# PCN – Product Change Notification

Document No	PCN-A-080521	Revision	1.0		
-------------	--------------	----------	-----	--	--

**ECN Topic: New 8.4 inches Panel Mount Dimension is integrated into Winmate's Panel PCs**

**New Front Bezel Dimension:**

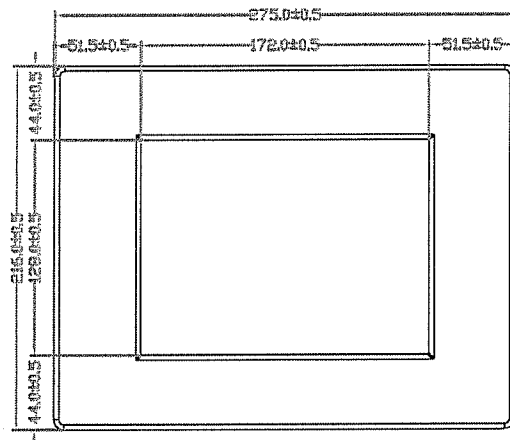
We will use a new 8.4 inches Panel Mount Front Bezel dimension for T series/T5 series/S series Panel PC. The dimension of Front Bezel will change to 275 x 216 mm from 270 x 204.8 mm and the Cut Out Dimension will change to 251.4 x 180 mm from 250.4 x 177.6 mm. The rest of the housing dimension will be the same to original ones.
